Countries:	CANADA, UNITED STATES	Document ID:	IK1200709
Availability:	ISIS, Bus ISIS, Fleet/ISIS	Revision:	5
Major System:	ENGINES	Created:	1/18/2012
Current Language:	English	Last Modified:	11/19/2012
Other Languages:	NONE	Author:	Collins Bonnema
Viewed:	5552

Title: EGR Bellows Tube

Applies To: MaxxForce 2010 13L and 11L Engines ESN: 4100000 and UP

Figure A

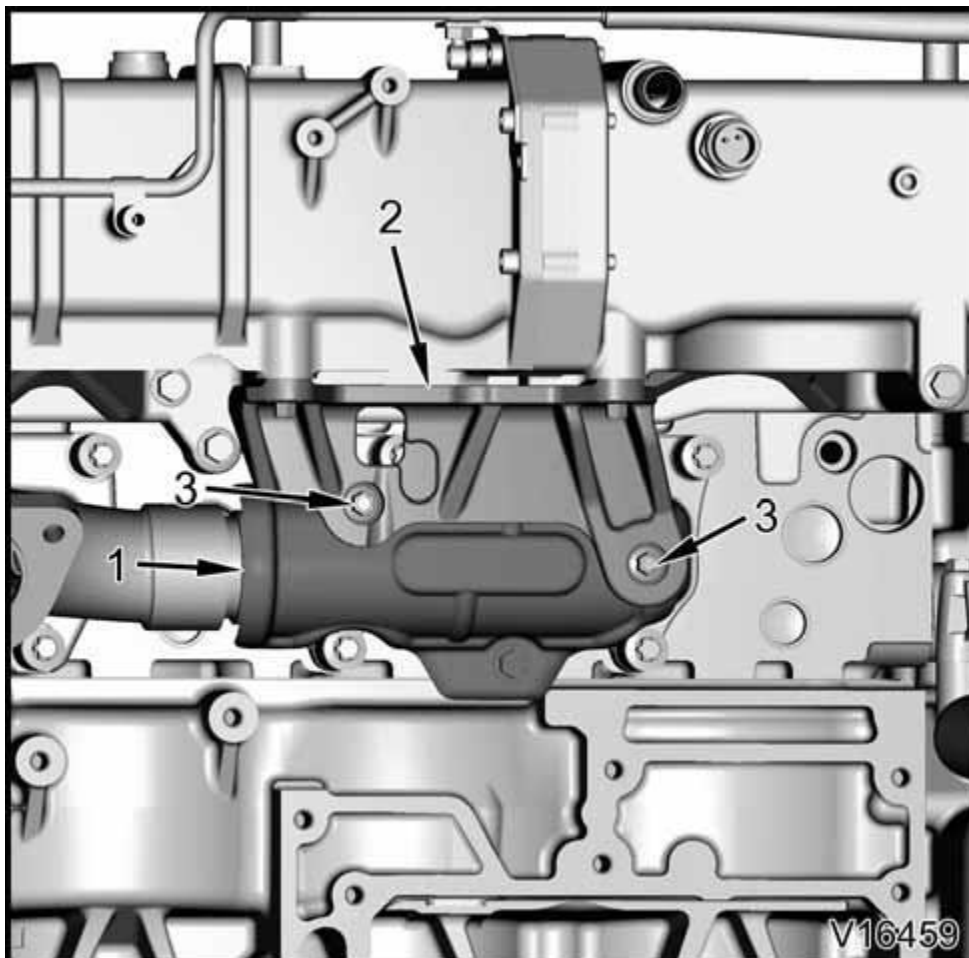
1. Inspect the EGR hot side inner (3005782C3) and outer (3005416C3) bellow tubes for cracks or exhaust leaks.
 2. Check the integrity of engine & chassis harness in the surrounding area. You will look for melted: split loom, connectors, and/or wire insulation.
 3. Lookup case file history. If complete or low temperature side EGR cooler has been replaced you will inspect for missing or loose of bolts in the "L" shaped bracket (Reference Figure A).
- A. The 2 vertical bolts, (up & down) are **OFTEN** found to be never re-installed or are left loose in the field after complete or partial EGR Cooler replacement. These **MUST** be installed. Your parts department will find you these vertical bolts through the parts system or local supplier.

Part Number: 1817957C1

Description: BOLT, FLANGE M8 X 25MM
